Spartan RV Chassis

Technical Service Bulletin
CSB21-250-001

- DATE:** March 8, 2021
- APPLIES TO:** This service bulletin applies to certain 2020 thru 2022 model year K2, K3 and K4 model Spartan RV motor home chassis with Vehicle Date of Manufacture (VDM) between December 12, 2019 and December 05, 2020 that are equipped with an Independent Front Suspension supplied by Reyco Granning, LLC.
- CONDITION:** The IFS lower shock mounting bracket fasteners may become loose over time and can shear, leaving the shock bracket dislodged from its intended location.
- CORRECTION:** See details below.
- LABOR ALLOCATION:** Up to 1 hour
- CLASSIFICATION:** V3
- TOOLS NEEDED:** 9/16" socket
Torque wrench capable of 35 LB-FT

Figure 1

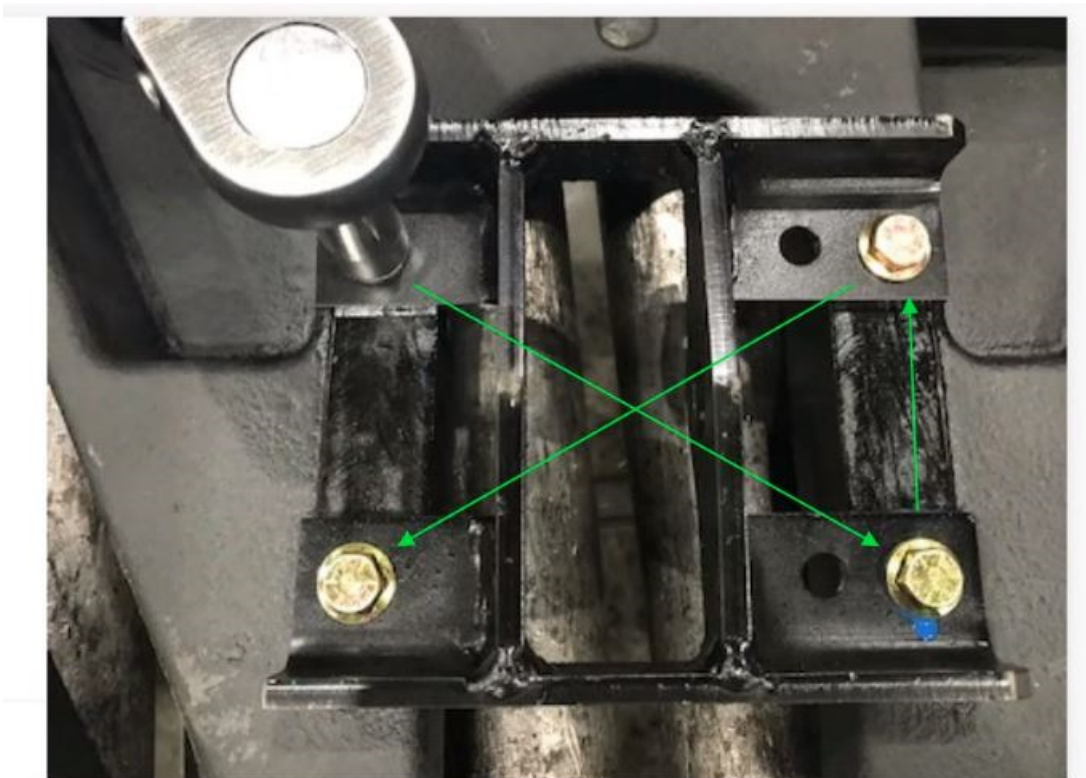
Referring to Figure 1, perform the following instructions one fastener at a time for each of the 4 bolts attaching the lower shock bracket to lower control arm. Use a cross pattern sequence.

1. Remove and discard bolt.
2. Clean threads in the lower control arm.
3. Install new 3/8-16 x 1.25" bolt and 3/8" Nord-Lock® washer. Torque to 35 LB-FT +/- 5 LB-FT. Mark fastener to indicate it has been torqued.
